ADDENDUM NO. 2

**LIFT STATION NO. 7 REPAIRS
PROJECT NO. 2011-S-1**

CITY OF GRAND ISLAND, NEBRASKA

RE: Addendum to expand bidding alternative in Arthur and Grant
repair method.

SHEET 7 OF 7

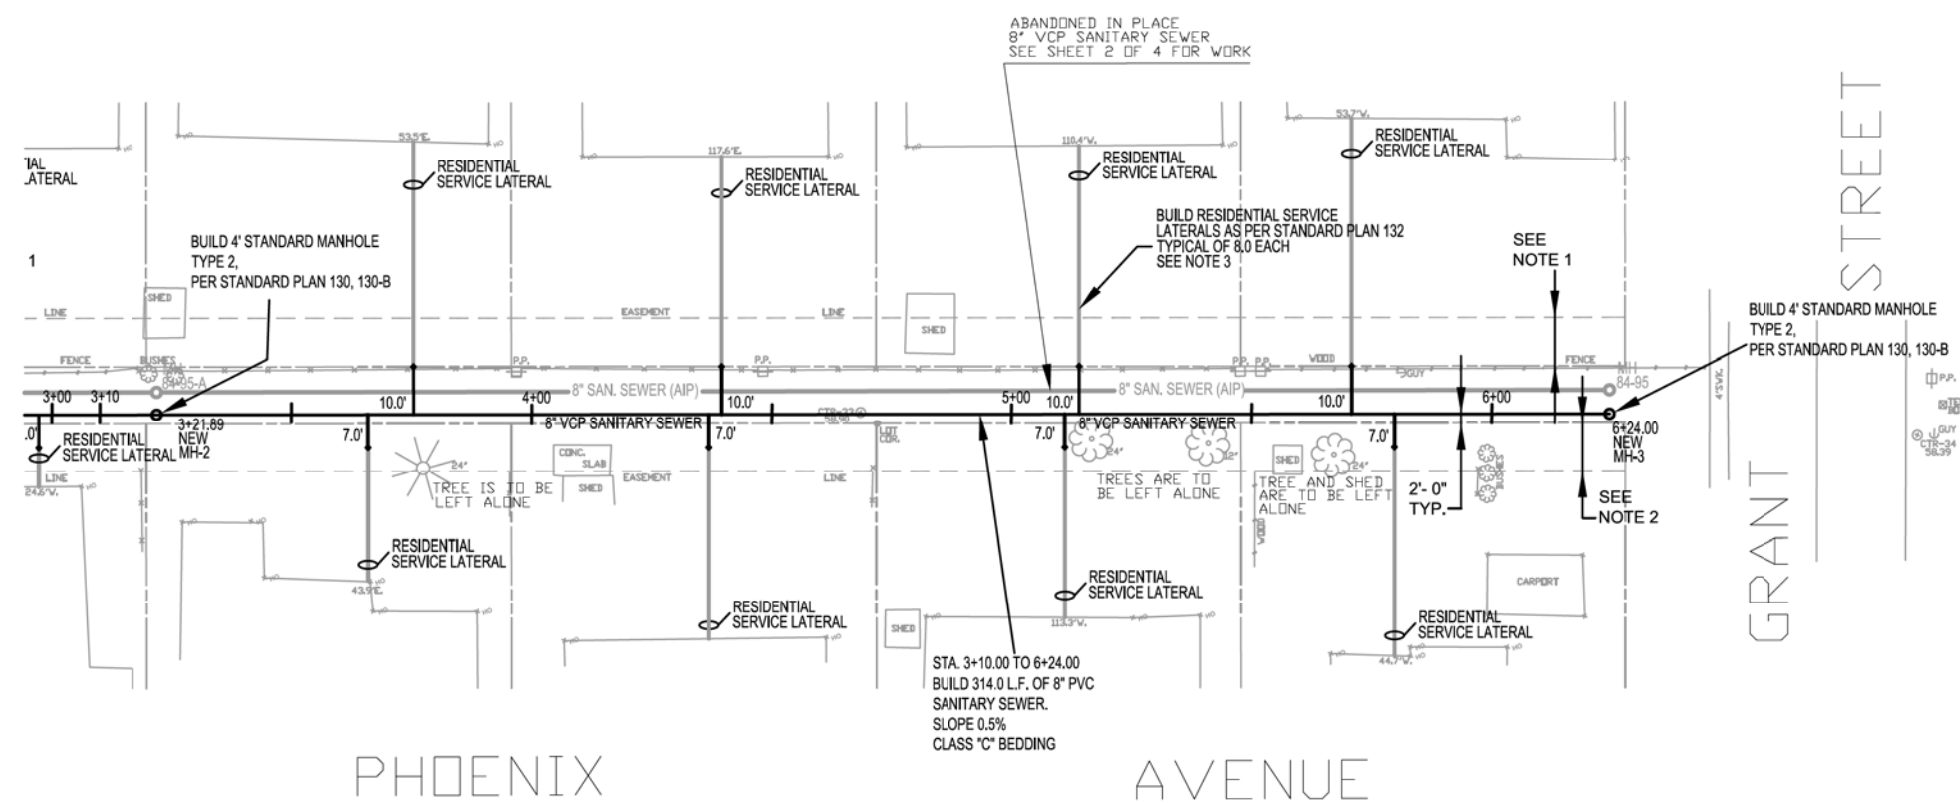
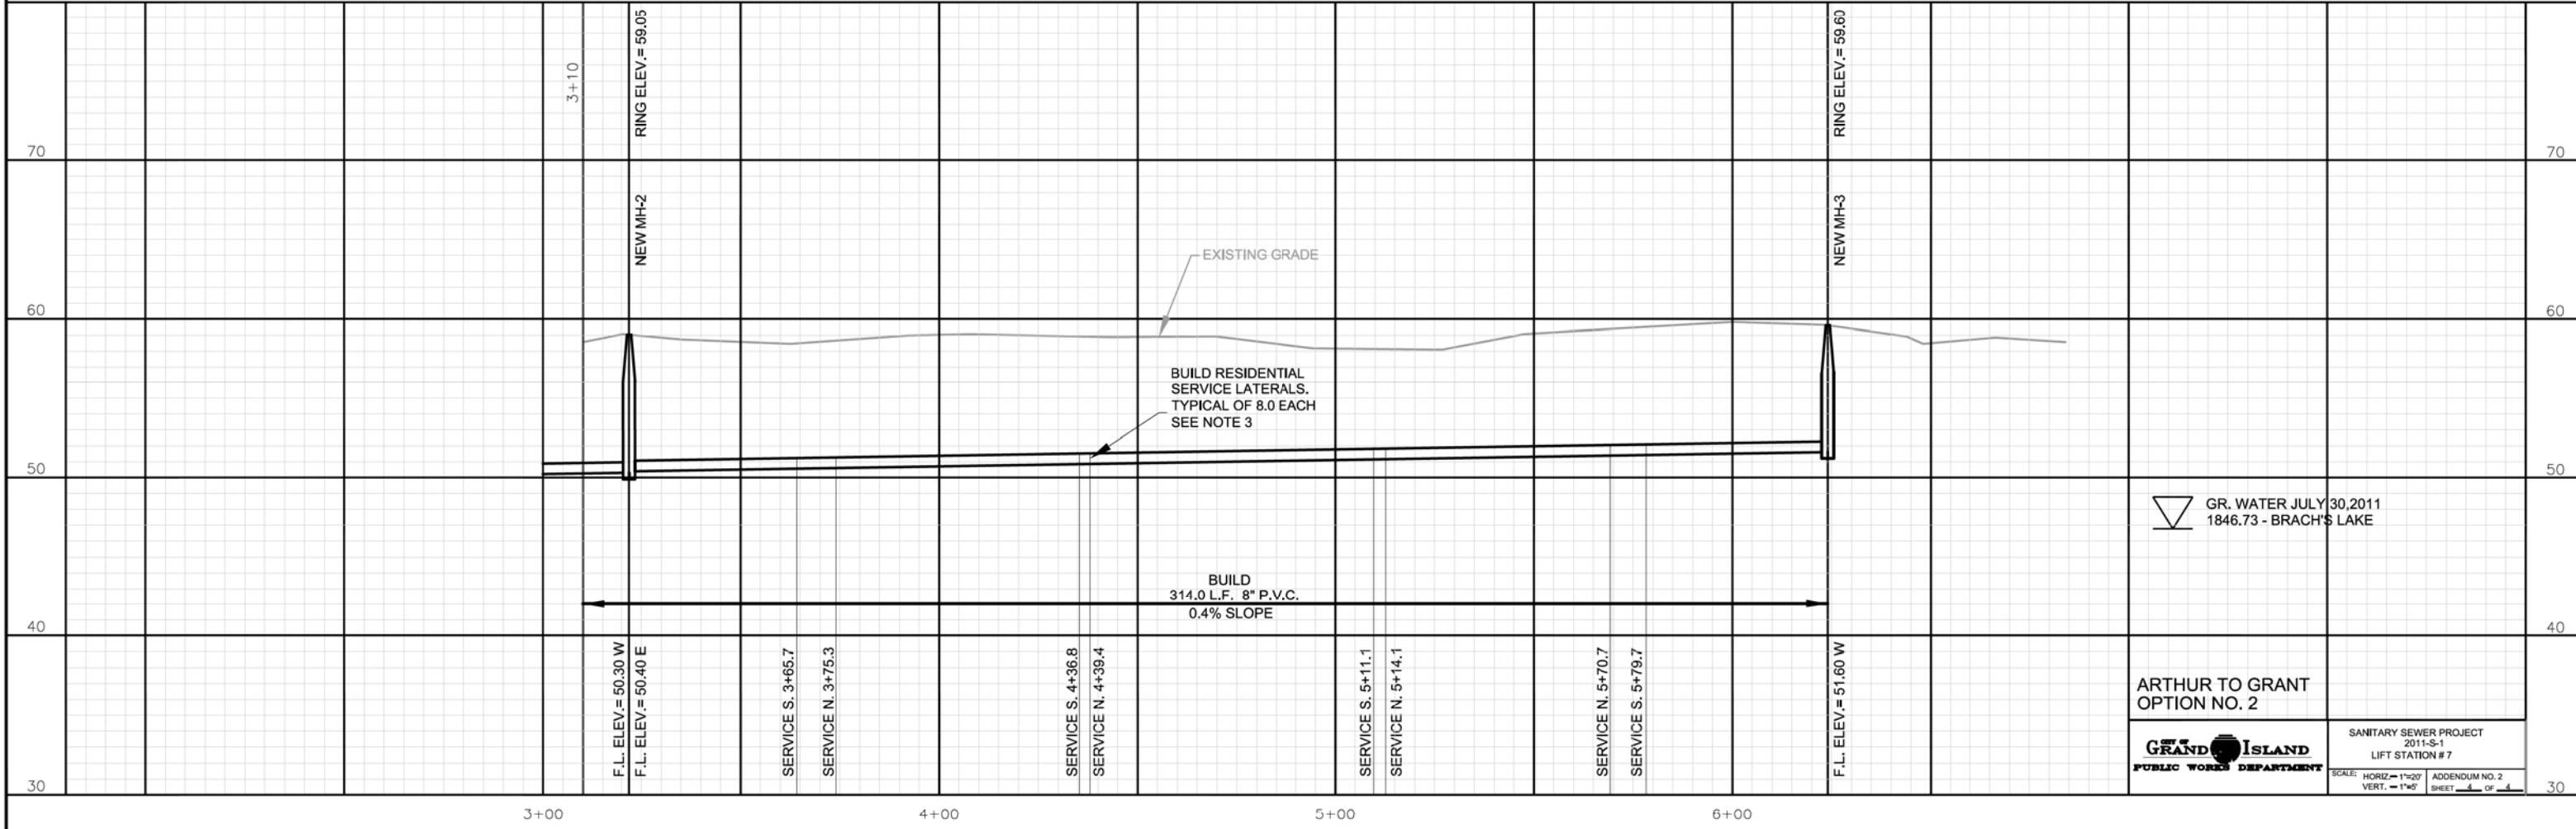
- NOTES:
1. 10' NORTH CONSTRUCTION EASEMENT, OBTAIN ENGINEER AUTHORIZATION PRIOR TO ENTRANCE.
 2. 10' SOUTH CONSTRUCTION EASEMENT.
 3. RESIDENTIAL SERVICE LATERAL UNIT SHALL COMPOSE OF MAIN LINE TEE CONNECTION, HORIZONTAL LENGTH (SHOWN ON PLANS), VERTICAL LENGTH (CONTRACTOR CONFIRMED), TWO (2) ANGLED FITTINGS, AND COUPLING.
